## HISTORIC AND DESIGN REVIEW COMMISSION

**HDRC CASE NO:** 2016-372  
**ADDRESS:** 415 MARY LOUISE  
**LEGAL DESCRIPTION:** NCB 6703 BLK 13 LOT 3  
**ZONING:** R6 H  
**CITY COUNCIL DIST.:** 7  
**DISTRICT:** Monticello Park Historic District  
**APPLICANT:** Adan Ochoa/AO Design  
**OWNER:** David Whitworth  
**TYPE OF WORK:** New construction of an accessory structure  
**REQUEST:**

The applicant is requesting a Certificate of Appropriateness for approval to construct a rear carport that is 540 square feet and 12'-1" tall at the ridge.

1 NORTH ELEVATION  
Scale: 3/16" = 1'-0"  
GRAPHIC SCALE

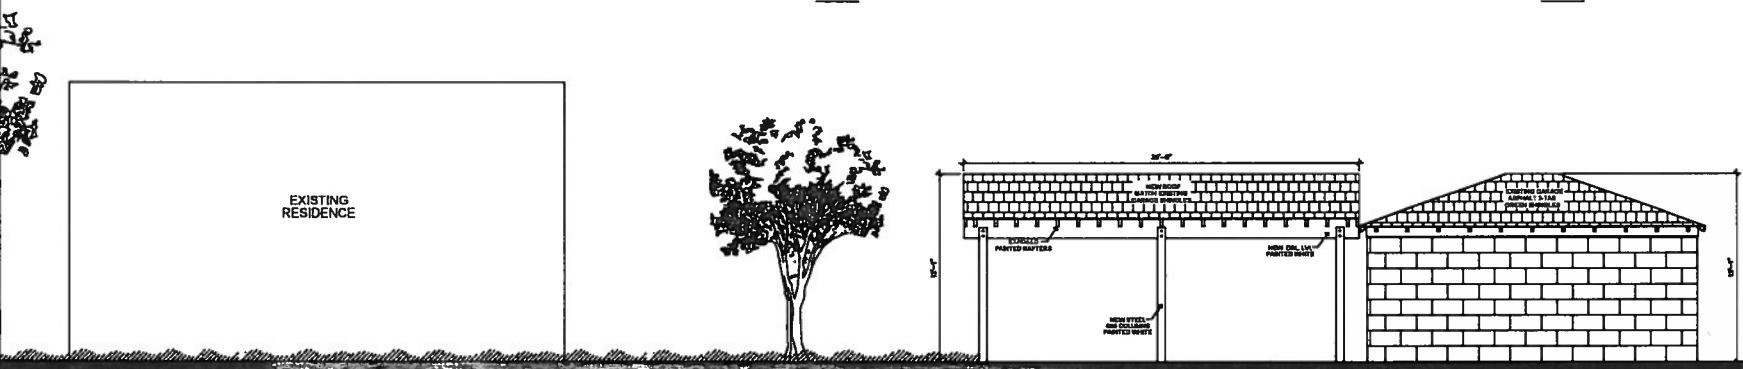
COMMENTS/CONCERNS: Cone: concerns about mismatched,  
higher eave EG: Does the eave match in  
the 2D-elevation. what is the use of the  
garage TC: I would support a variance  
to encroach in setback. OK with scale  
and location but concerns with overhang  
detail. EG: Rafter tails on N are flush, but  
on side elevation are not. TC: Drew image on  
dry erase board showing detail of eave of what's existing.

TC: Carport needs to line up with existing garage walls, or centered on existing walls. The open side carport allows for width.

EG: Are there any gutters on existing rear house? If not, details wouldn't match ~~or~~ if added to carport & not rear house.

1. That the ridge height of the garage be the same as or below the height of the historic garage.
2. That the eaves of the proposed carport match those of the existing rear garage.
